DART AEROSPACE LTD		Work Order:	134083
Description: Crosstube High Fwd (407)		Part Number:	D407-667-105
Inspection Dwg: D407-667-145 Rev: C		Page 1 of 1

DESIGN	CP	DART AEROSPACE LTD	
DRAWN	RF	HAWKESBURY, ONTARIO, CANADA	
CHECKED	CP	DRAWING NO. D407-667-145	REV. C
MFG. APPR.	CP	SHEET 4 OF 4	
APPROVED	CP	TITLE	SCALE
DE APPR.	CP	CROSSTUBE ASSY (407 HIGH FWD)	NTS
DATE	08.11.06	COPYRIGHT © 2002 BY DART AEROSPACE LTD THIS DOCUMENT IS PRIVATE AND CONFIDENTIAL AND IS SUPPLIED ON THE EXPRESS CONDITION THAT IT IS NOT TO BE USED FOR ANY PURPOSES OR COPIED OR COMMUNICATED TO ANY OTHER PERSON WITHOUT WRITTEN PERMISSION FROM DART AEROSPACE LTD.

DRAWING NO. D407-667-145	TITLE CROSSTUBE ASS'Y (407 HIGH FWD)	REV. C	DART AEROSPACE LTD ENGINEERING ORDER		D.E.O. NO. D407-667-145-C-1	SHEET NO. SHEET 1 OF 1	SCALE NTS
DRAWN <i>qp</i>	CHECKED <i>ASS</i>	MFG. APPR. <i>108</i>	APPROVED <i>MD</i>	DE APPR. <i>11</i>			
DATE 11.07.15	DATE 11.07.22	DATE 11.07.22	DATE 11/07/22	DATE 11.07.21

DRAWING NO. D407-667-145	TITLE CROSSTUBE ASS'Y (407 HIGH FWD)	REV. C	DART AEROSPACE LTD ENGINEERING ORDER		D.E.O. NO. D407-667-145-C-2	SHEET NO. SHEET 1 OF 1	SCALE NTS
DRAWN AJ5	CHECKED	MFG. APPR.	APPROVED		DE APPR.		
DATE

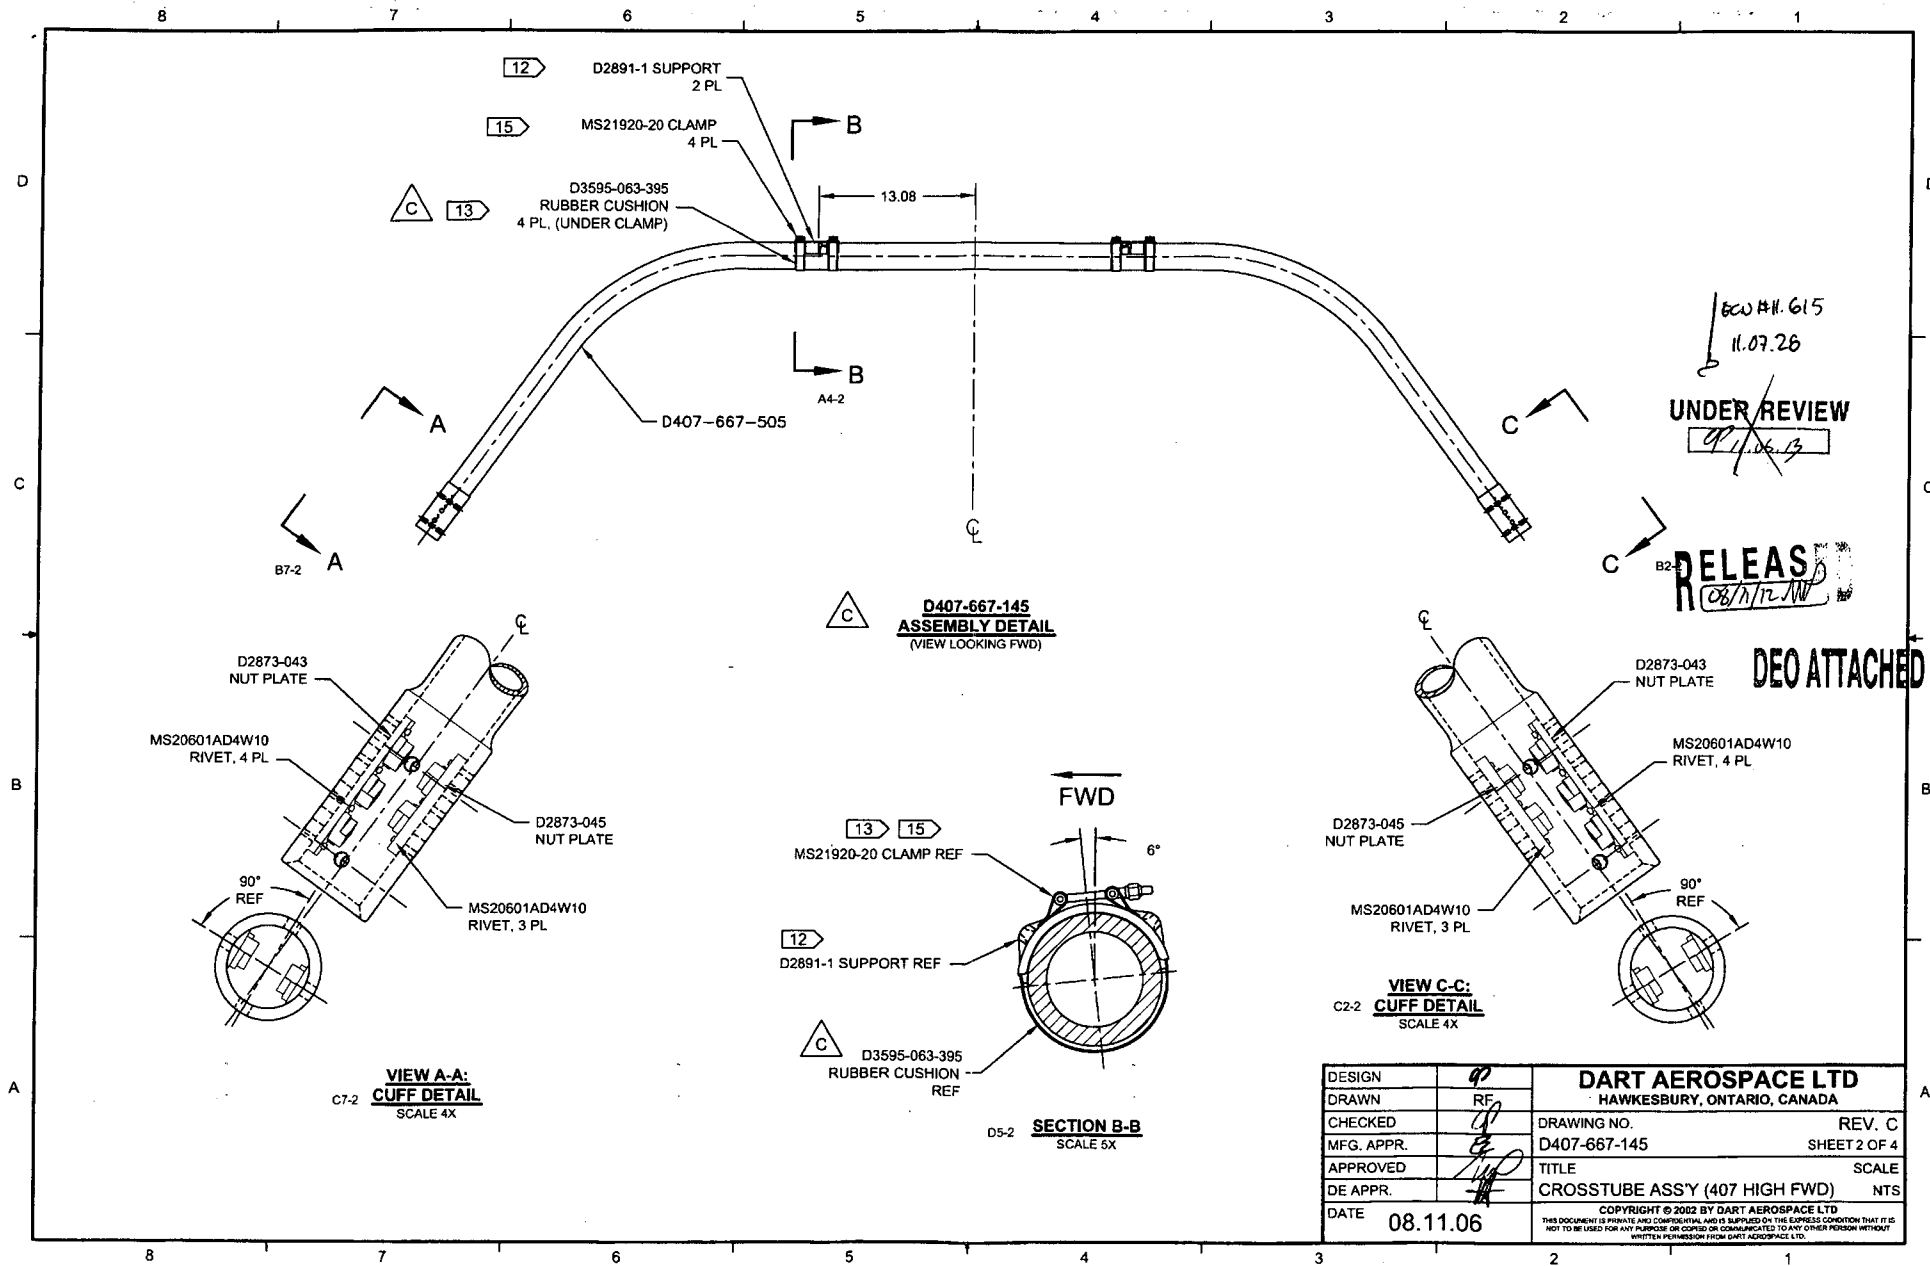
PURPOSE:

REPLACE MAGNOBOND WITH PROSEAL.

NOTE 12 & 15, SHEET 1 IS AMENDED AS FOLLOWS:

- 12) TO INSTALL D2891-1 SUPPORT: ABRABE MATING SURFACE OF SUPPORT AND CROSSTUBE WITH 180-GRIT SANDPAPER AND REMOVE RESIDUE WITH MEK (OR EQUIVALENT). APPLY A 0.04" TO 0.07" THICK LAYER OF PROSEAL 890 CLASS B-2 (OR AMS-S-8802 CLASS B-2) SEALANT TO MATING SURFACE OF SUPPORT.
- 15) TORQUE CLAMPS 80 TO 100 IN-LB. ENSURE AT LEAST 1.5 THREADS SHOWING IN SAFETY AND THAT NUT HAS NOT BOTTOMED-OUT AFTER TORQUING. **PRIOR TO PACKAGING, RE-CHECK TORQUE ON CLAMPS AFTER PROSEAL 890 SEALANT HAS CURED FOR 72 HOURS.**

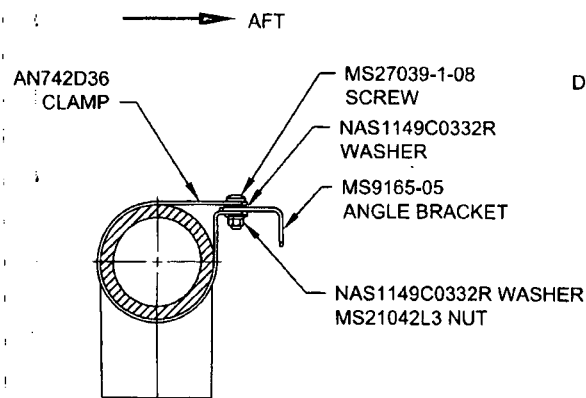
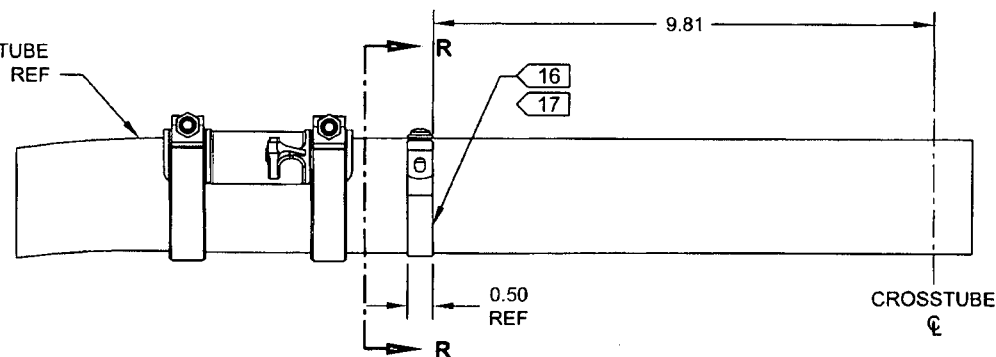
PURPOSE:

ADD ELECTRICAL GROUNDING STRAP

ITEM	QTY -145	PART NUMBER	DESCRIPTION
1	X	D407-667-145	CROSSTUBE ASSEMBLY (407 HIGH FWD)
10	2	AN742D36	CLAMP
11	2	MS9165-05	ANGLE BRACKET
12	2	MS21042L3	NUT (OR MS21042-3)
13	2	MS27039-1-08	SCREW
14	4	NAS1149C0332R	WASHER (OR AN960C10L)

DETAIL P
BONDING STRAP INSTALLATION 2 PL
